## **PLANNING BOARD AGENDA FOR JANUARY 13, 2026 - 7:00 PM**

1. **Salem NIM, LLC Site Plan** – Public Hearing for change of use for 19,960 sq. ft. restaurant and entertainment use with conditional use permit for reduced parking and additional signage at 11 Mall Road, Map 107, Lot 11154. Continued from 12/9/2025.

Below please find our responses comments discussed in our December 9 2025 meeting and at the PB meeting. Below please find each comment followed by our response in **bold**.

# LYONS GROUP RESTAURANT AT THE MALL AT ROCKINGHAM PARK PLANNING BOARD SUBMISSION

# COLORED EXTERIOR ELEVATIONS

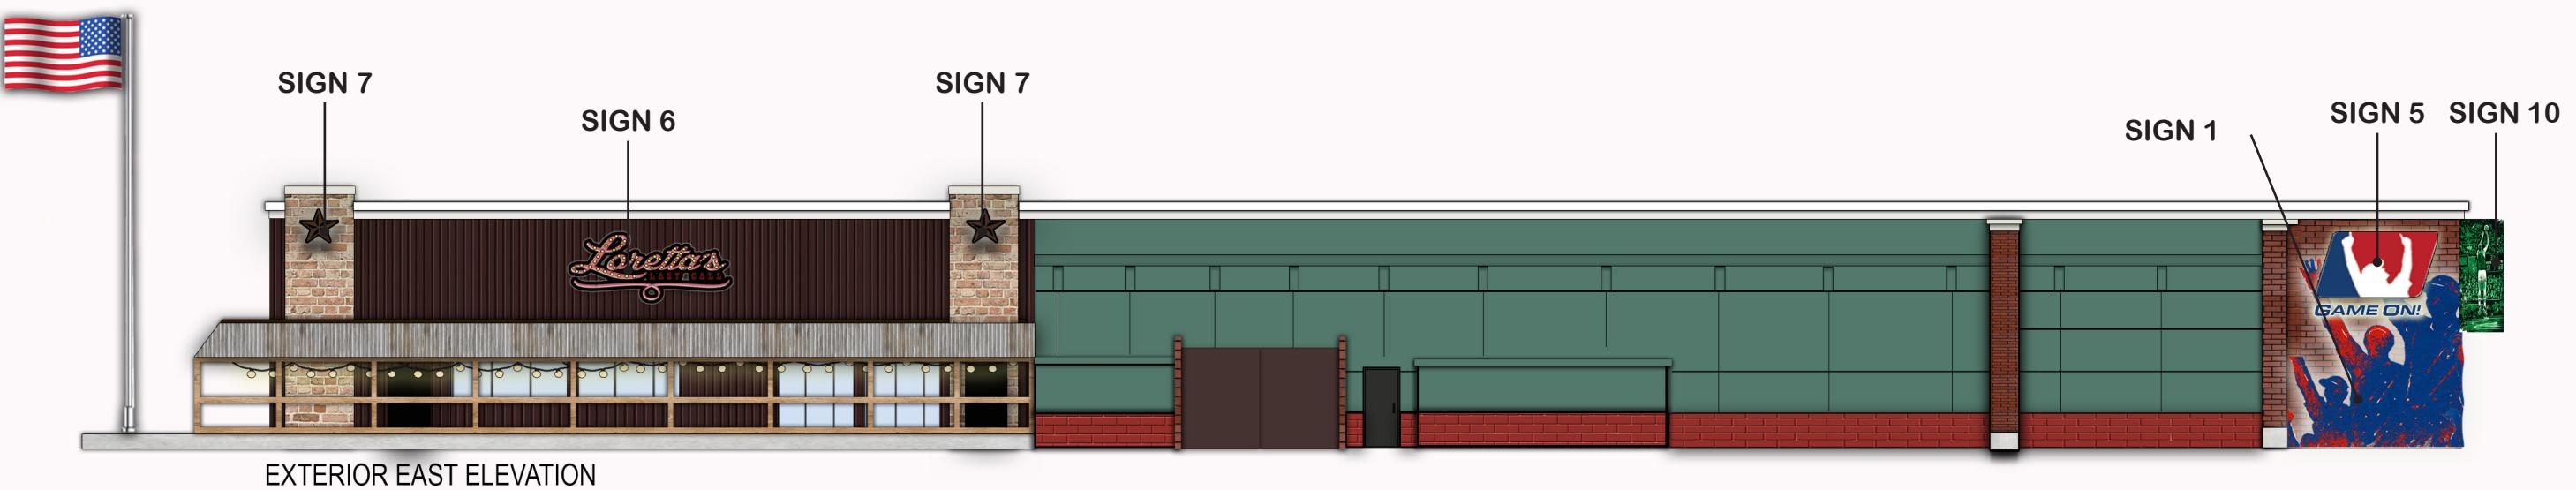
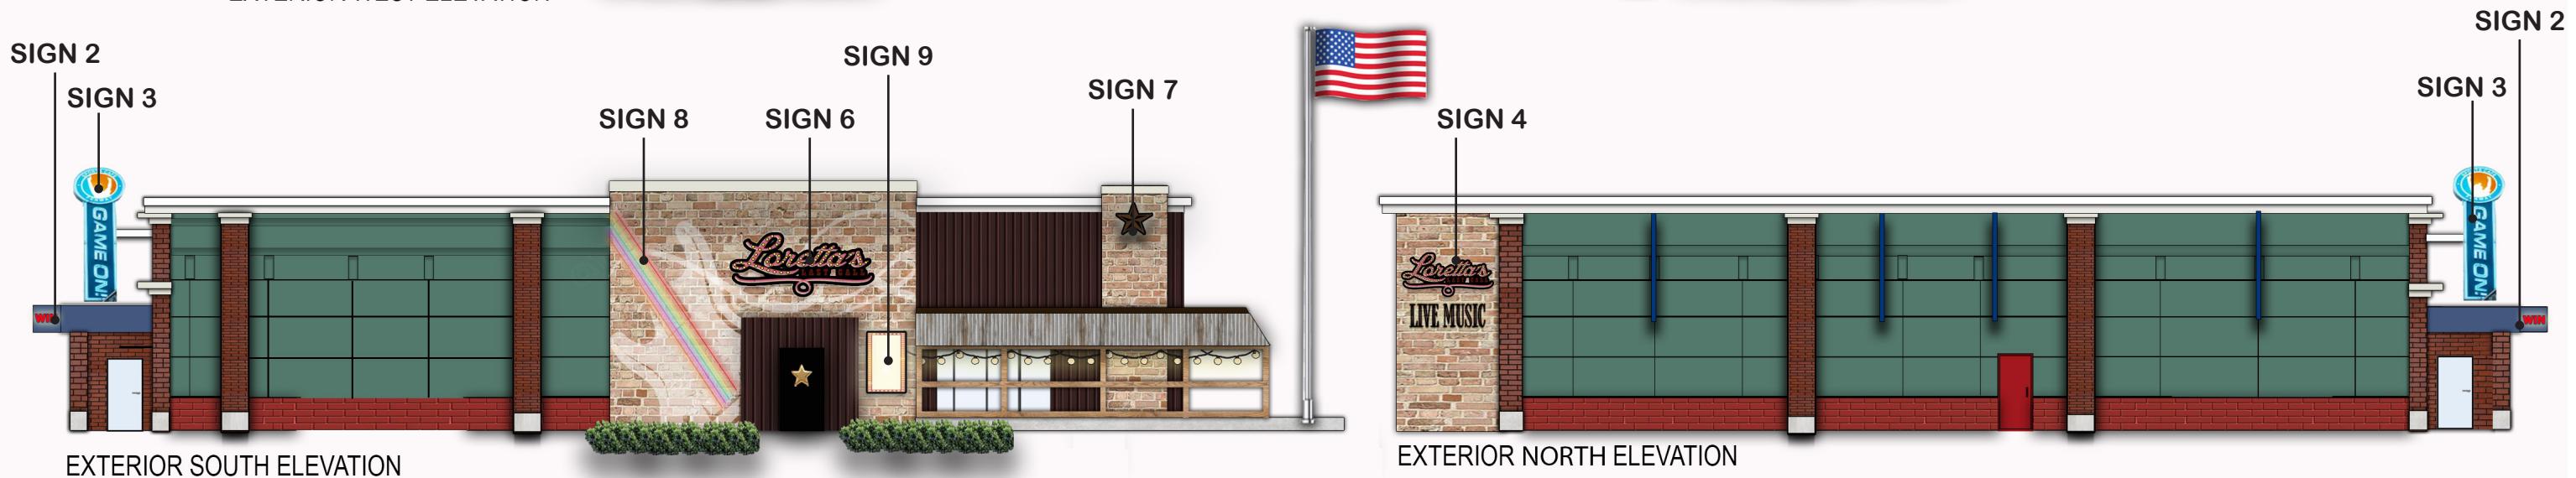
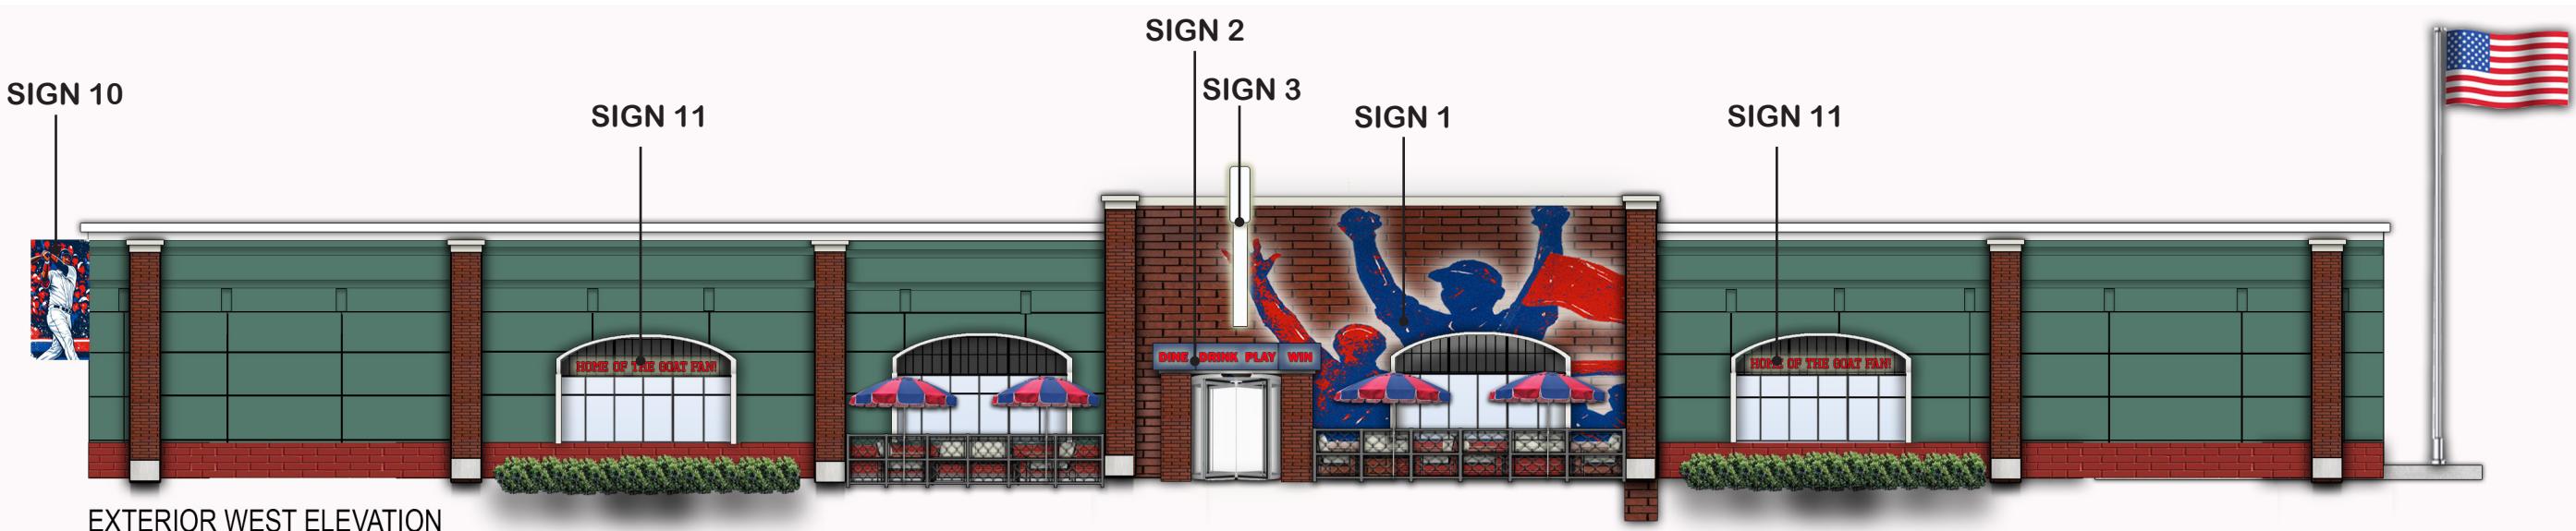
- Elevations:
  - Add legend – materials and color

fence; adding new brick for equipment storage and dumpster enclosure. Proposed modifications are attractive and welcomed improvements however building has blank walls on large portions of western, northern and eastern facades and eliminated transparency on western facade. Elevations should still be revised to better comply with Site Plan Regulations and Design Guidelines (see excerpts attached) – specifically to reduce blank walls, increase transparency, vary roofline; dumpster enclosure should be revised to match building.”

**COMMENT RESPONSE:** Additional page has been added to the plans with the legend.
  - See [Design Guidelines](#) for Façade Design – pages 30-33
    - “For retail structures, any facade that faces a public or private street should have display windows, entry areas, or other transparent features along 40% or more of its horizontal length... Facades should not extend for more than 50 horizontal feet in length without incorporating architectural features, such as pilasters, windows, cornices, porches, corners, or offsets.”

- **COMMENT RESPONSE:** This concern was addressed by adding the large window on either side of the entrance as well as two additional large windows beyond those two windows that are decorative.

**COMMENT RESPONSE:** This concern was addressed by adding the large window on either side of the entrance as well as two additional large windows beyond those two windows that are decorative. In addition, we have added banners on the North side of the building as well as an additional pilaster on the east face behind the equipment enclosure.
